**Snowdonia Aerospace Airspace Change Proposal  
Revised Design (Stage 4A), ACP-2019-58  
Llanbedr Danger Area (DA)**

**This report documents the Revised Airspace Design as part of the “Stage 4A Update Design” element of the Snowdonia Aerospace LLP submission for an Airspace Change Proposal, Reference: ACP-2019-58, Llanbedr Danger Area (DA), under the Civil Aviation Authority (CAA) CAP1616 Airspace Change Process.**

Figure 5 – Draft airspace design Option #2 for ACP-2019-58, Llanbedr Danger Area (DA)

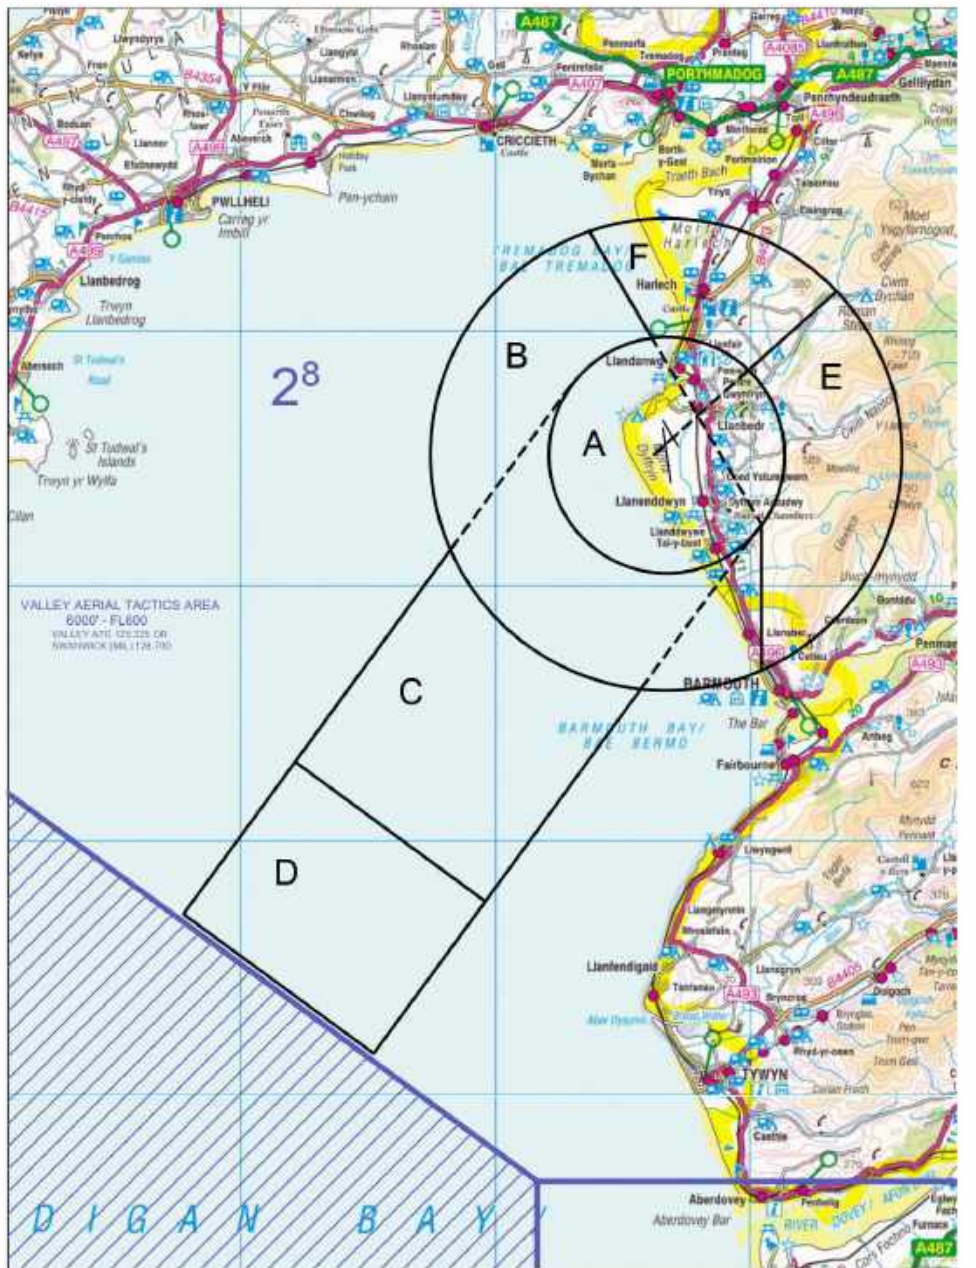
The revised design, Option #2b, is presented in Figure 6. Compared to the original Option #2 design shown in Figure 5, Area D has been increased in length from 4 to 5 nautical miles and Areas E and F have been simplified to improve GA transit to the east when Areas A, B and / or F are activated and also to ease issues raised by some respondents in relation to overland operations. This has resulted in a clipping of Area A such that it would no longer be completely coincident with an ATZ (if one were to be implemented in future) but is still entirely consistent with the major dimensions.

**Fig. 6 - Final Airspace Design (Option #2b) for ACP-2019-58, Llanbedr Danger Area, incorporating the revisions suggested from the consultation**

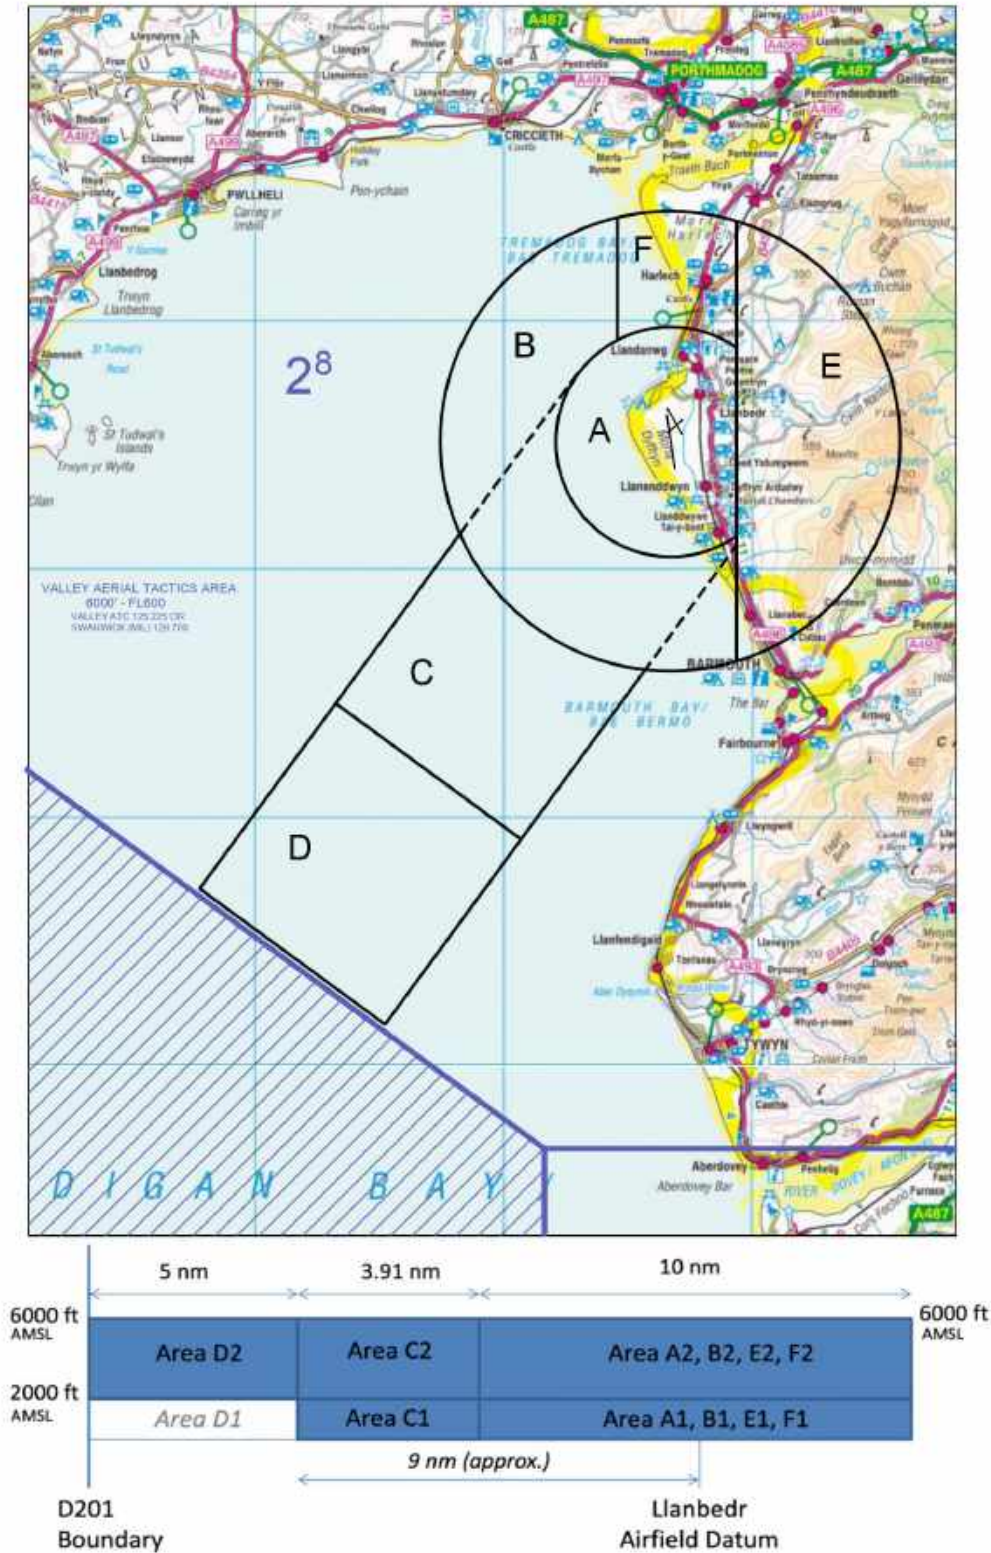
A simplification of the sub-divisions for Areas E and F to provide easier assimilation and a clearer north-south transit corridor transit for General Aviation away from the higher ground.

A lengthening of Area D from 4 nautical miles to 5 nautical miles to provide a larger buffer between the Llanbedr DA and the existing D201 and reduce any funnelling effect for military aircraft transiting to the west between both Danger Areas.

One particular issue raised by the MOD was in relation, in their opinion (Appendix A), to the potential for GA and other low-level military traffic to be funnelled through Area D when Llanbedr and other DAs in the vicinity were active, which may lead to a perceived increased risk of inadvertent penetrations of D201, or potentially force aircraft to fly towards the high ground inland from Llanbedr. We believe that the two main changes to the airspace design which we have now implemented as a direct result of the consultation feedback, will significantly mitigate any perceived risk by (i) creating a corridor through Area E for GA aircraft to stay to the east of the airfield for the vast majority of the time that the DA is active without having to fly towards high ground, and (ii) lengthening Area D from 4 to 5 nautical miles to increase the buffer to D201 and also reduce the potential for funnelling. Addressing (i) will also benefit item (ii) because making it easier for GA to pass to the east of the airfield will obviate the need for them to divert far out to the west and thereby leave this area clear for military aircraft to transit over / under the Llanbedr DA corridor or through the gap between the Llanbedr DA and D201.

The dimensions of Area D were previously carried over from the original definition for the TDA and had been set so as to enable an engine out (or similar emergency) recovery back into Area C (or returning to D201) without dropping through the "floor" in Area D and inadvertently entering non-segregated Class G airspace. This assumed that the recovering aircraft would have a glide ratio greater than 6:1. Increasing the length of Area D increases the required glide ratio to greater than 7.5:1, but it should be noted that a glide ratio greater than 15:1 would actually be required to recover from the far edge of Area D back to Llanbedr without ditching. Given that other mitigations should be put in place so that the risk of such an event is as low as reasonably practicable – and will be assessed as part of the CAA review of individual Operating Safety Cases (OSC) – we feel that the recovery glide ratio should not be a driving factor in the definition of Area D and that the proposed revision still represents a reasonable and proportionate balance between the competing requirements of different airspace users.
